**RE: Champion Xpress Car Wash  
9640 Universe Blvd. NW  
Grading and Drainage Plan  
Engineer's Stamp Date: 03/25/22  
Hydrology File: B10D003J**

Based upon the information provided in your submittal received 03/25/2022, the Grading & Drainage Plan is **not** approved for Building Permit. The following comments need to be addressed for approval of the above referenced project:

Sheet No.:  
**C-3.0**

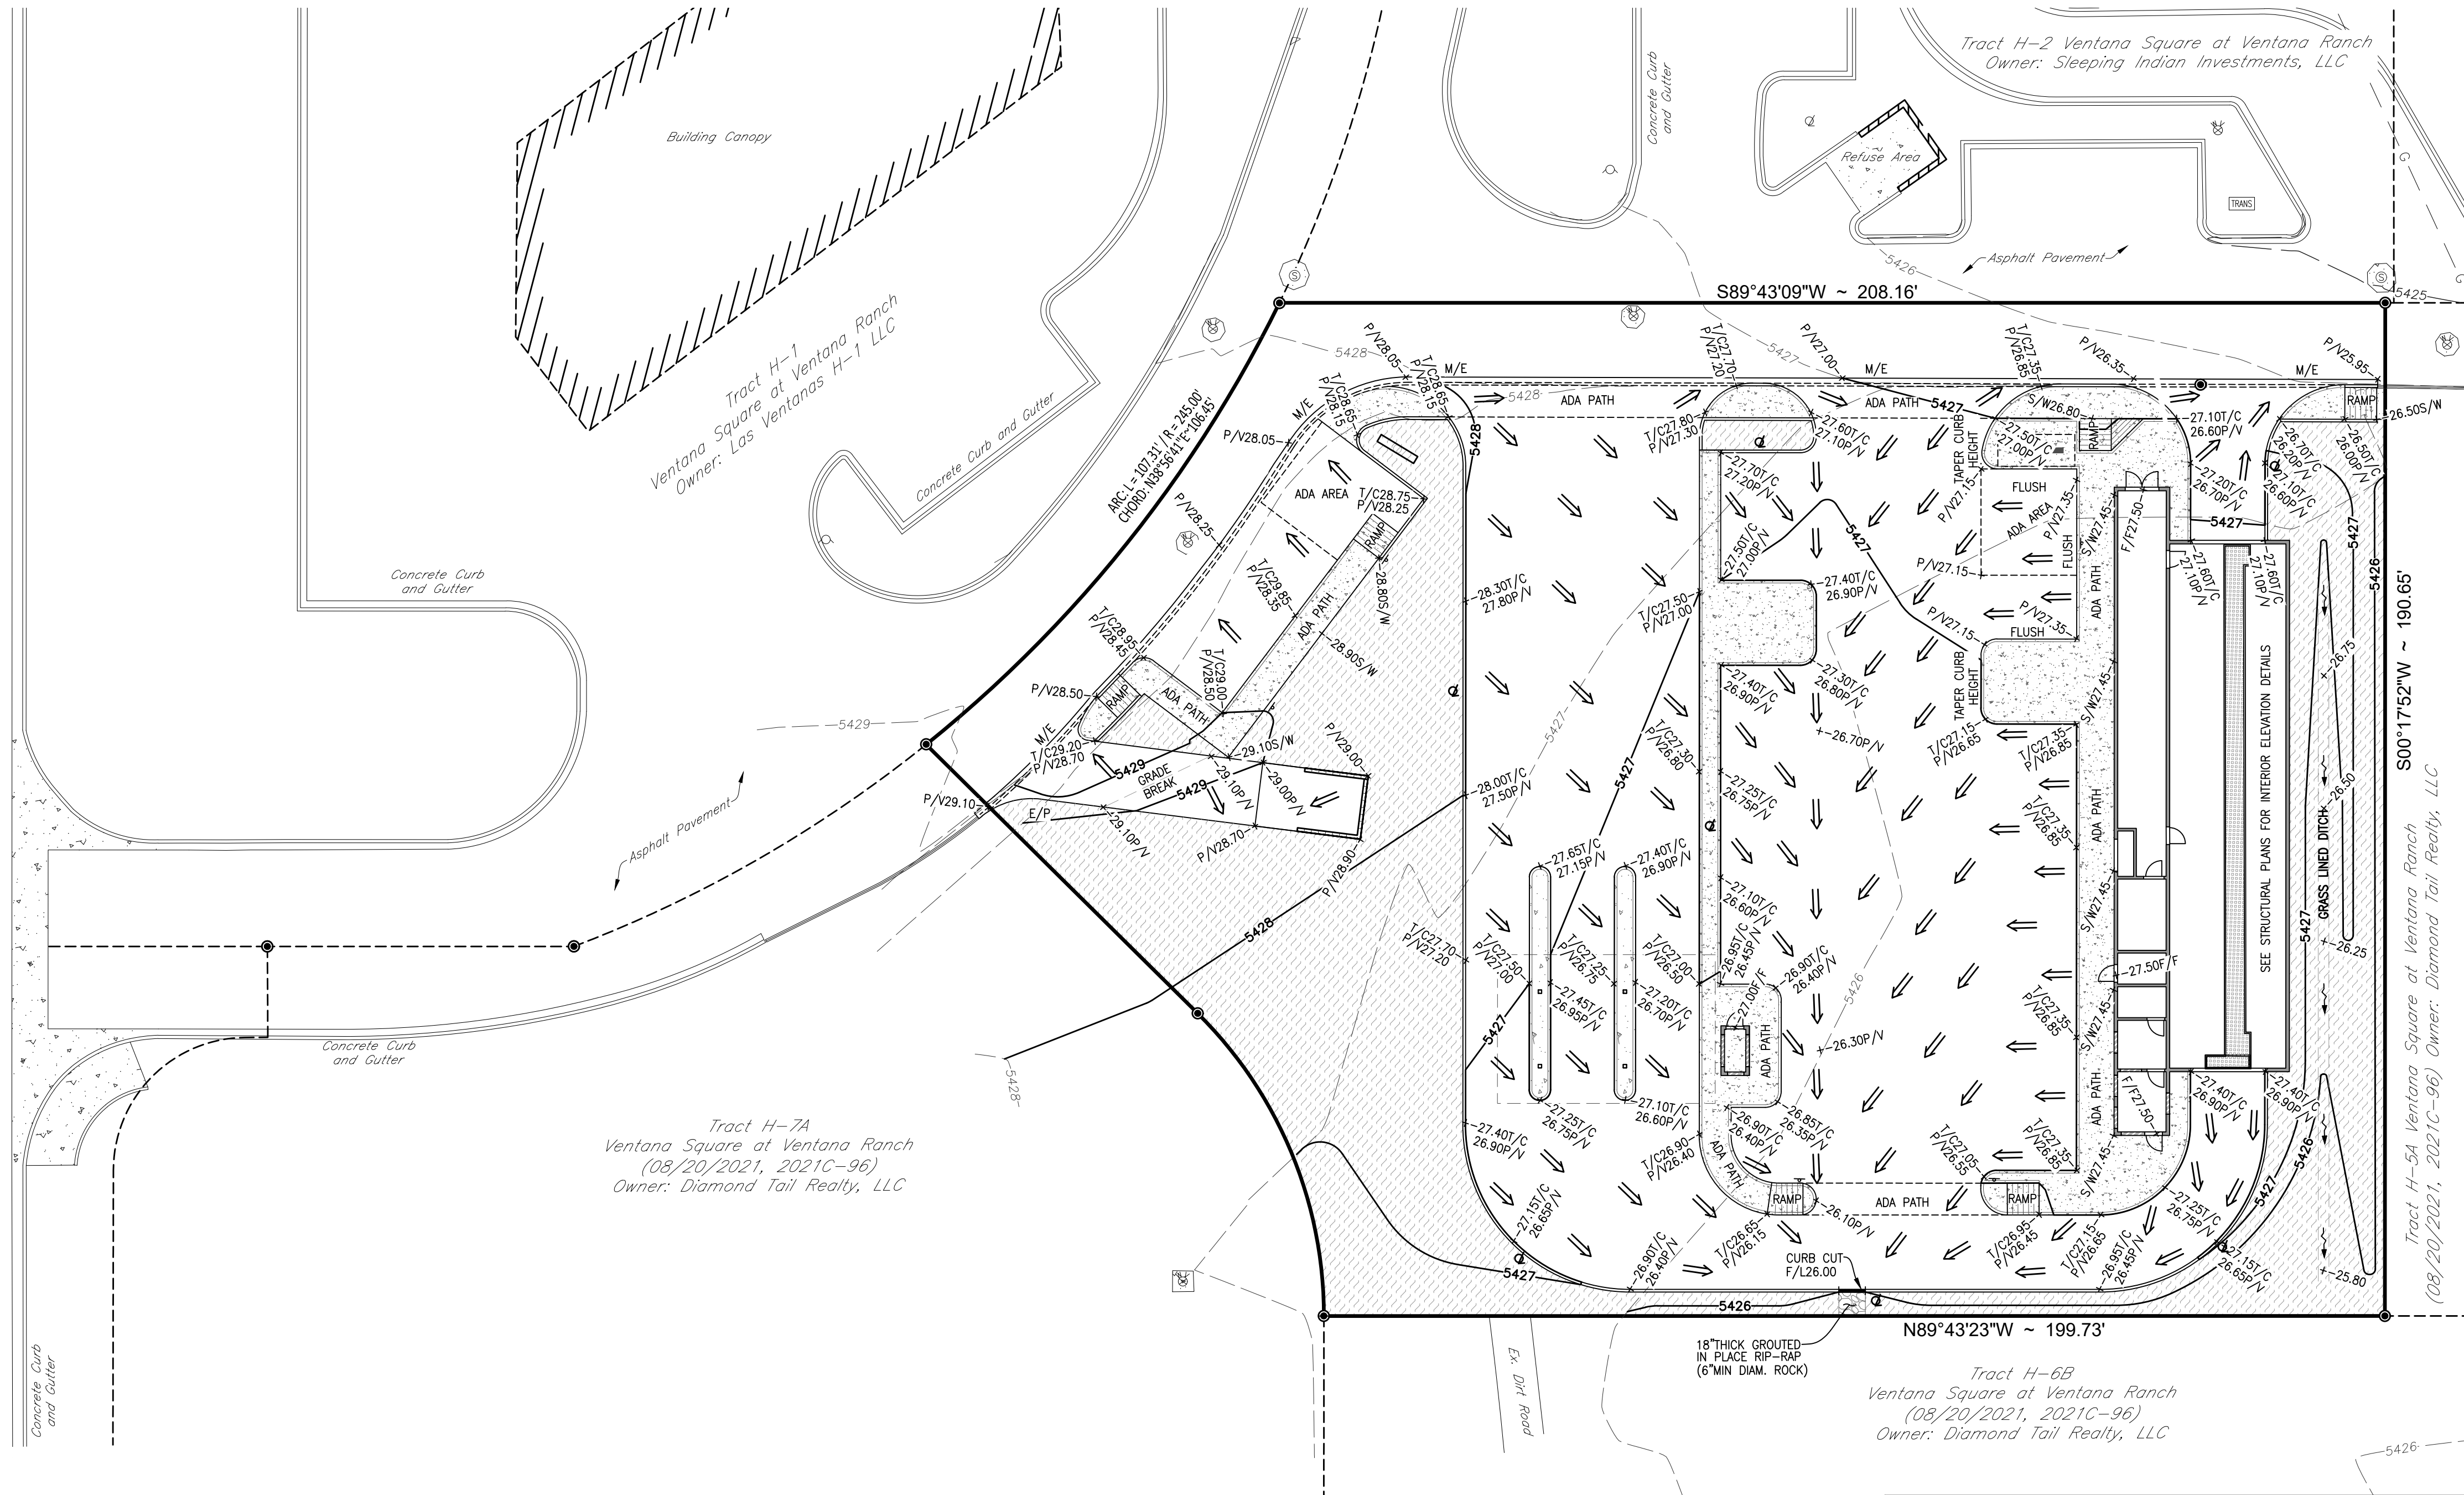
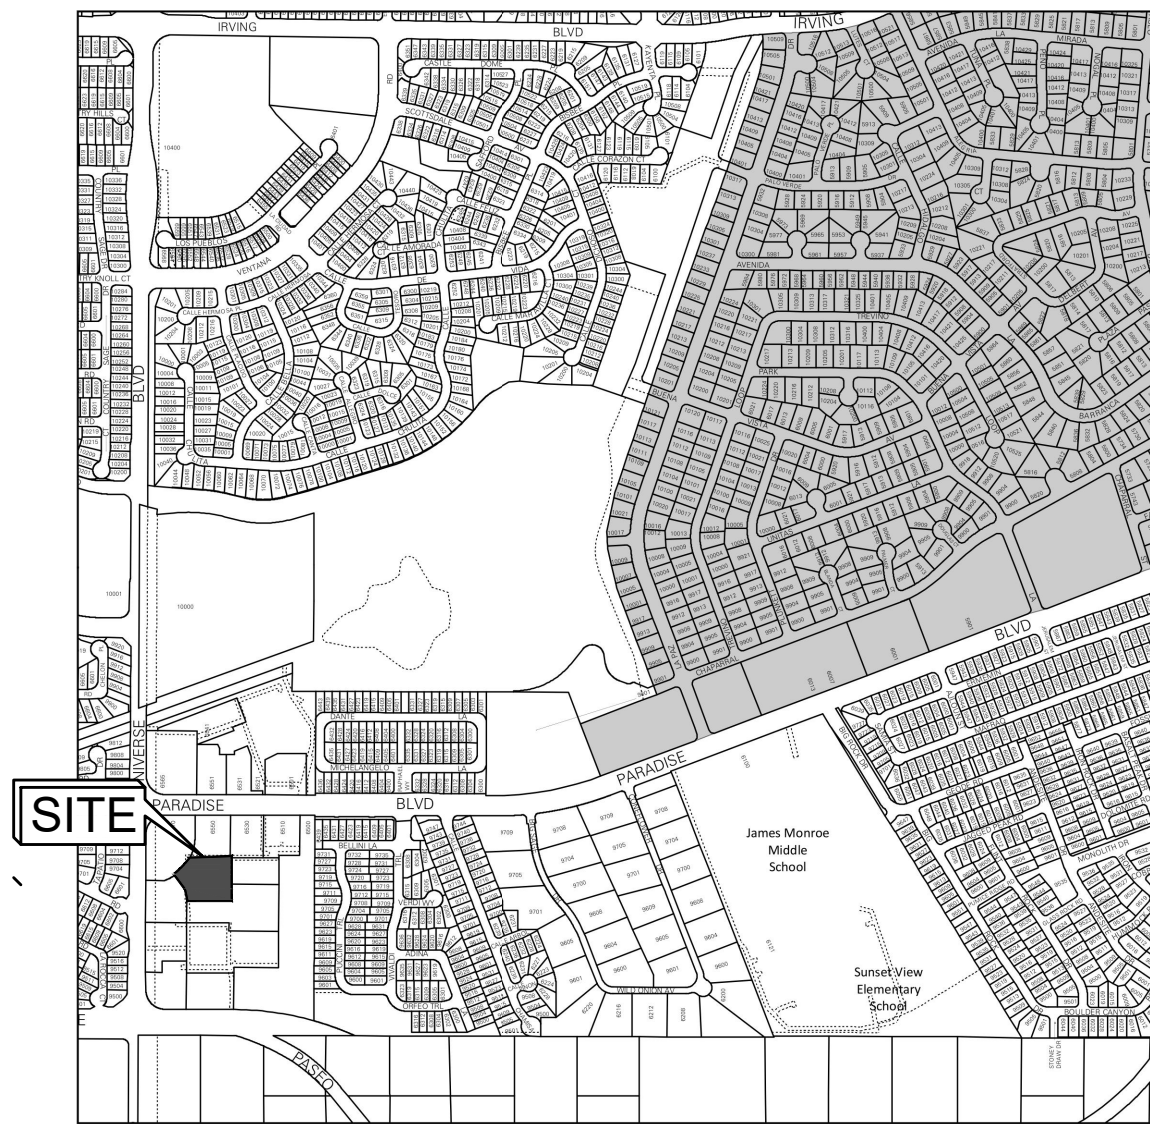
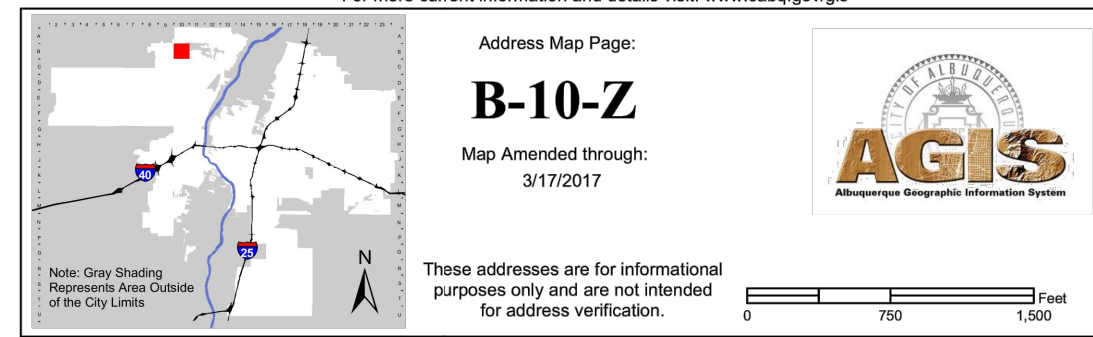
1. Please provide the Benchmark information (location, description and elevation) for the survey contour information provided.
2. Please use the procedure for 40 acre and smaller basins as outlined in Development Process Manual (DPM) (signed 06/08/20) Article 6-2(a). Please provide both the existing conditions and proposed conditions for the 100 year-6 hour storm event. Under the proposed conditions, please mention the overall Master Drainage Plan for Ventana Square Subdivision by Thompson Engineering dated 12/23/20 and the allowable discharge for this site as 3.51 cfs.

3. Provide management onsite for the Stormwater Quality Volume (SWQV) in accordance with the new drainage ordinance, § 14-5-2-6 (H) enacted 10/2/18 (Council Bill C/S O-18-2). Please show the top and bottom of the ponds along with the volume for each pond. The onsite drainage should be directed to these ponds prior to being collected in a private

unground drainage system. Please follow the DPM Article 6-12 Stormwater Quality and Low-Impact Development for the sizing calculations. To calculate the required SWQV, multiply the impervious area draining to the BMP by 0.42 inches for new development sites. The calculations of both the required and the provided volume of each BMP must be shown on the Grading and Drainage Plan. Each BMP should be labeled on the Grading and Drainage Plan with the required SWQV and associated water surface elevation and the 100-year water surface elevation. Landscaping of surface BMPs is also required to be noted on the Grading and Drainage Plan.

4. Please show the proposed access road for Ventana Square Subdivision (built under CPN # 670982. Also, please show and label the 20' Waterline Easement. Please note that the curbing and sidewalk along this access road is to be built during Building Permit with these plans which needs to be shown and called out.
